OXFORDSHIRE COUNTY COUNCIL'S RESPONSE TO CONSULTATION ON THE FOLLOWING DEVELOPMENT PROPOSAL

Application no: 22/00747/OUT

Proposal: Outline planning application for the development of up to 370 homes, public open space (including play areas and woodland planting), sports pitches and pavilion, drainage and engineering works, with all matters reserved (appearance, landscaping, layout and scale) except for vehicular and emergency accesses to Bicester Road.

Location: Land At Bicester Road Kidlington

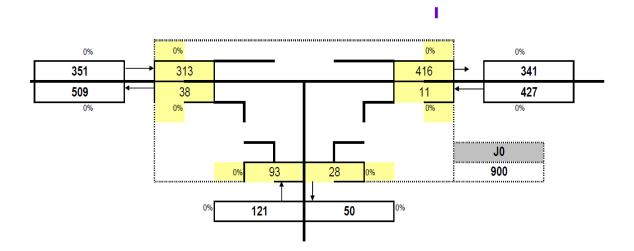
The resultant traffic flow diagrams have been appended to the TA, interrogation of which is seemingly impossible to interpret. First, the diagrams need to show base year flows before introducing development flows, but instead the application has presented all movements under the future year scenario. The flow diagram is hence incoherent and needs to be simplified further. Turning movements cannot be interpreted, taking an example of the site access junction below;

The above snippet is the distribution of vehicles plus development in 2031 AM peak. I however fail to interpret where 38 is taken from the 93 movements on the left turn from the site? The 28 movements shown to be accessing the site need to be explained.

- Besides the site access junction and the Kidlington roundabout, other junctions mapped on the flow diagram are simply a guess work.
- Arms of junctions need to be named
- It would be helpful for base year flows, committed development flows and future year flows to be separated out
- What is the significance of the percentages are shown, what do they stand for?
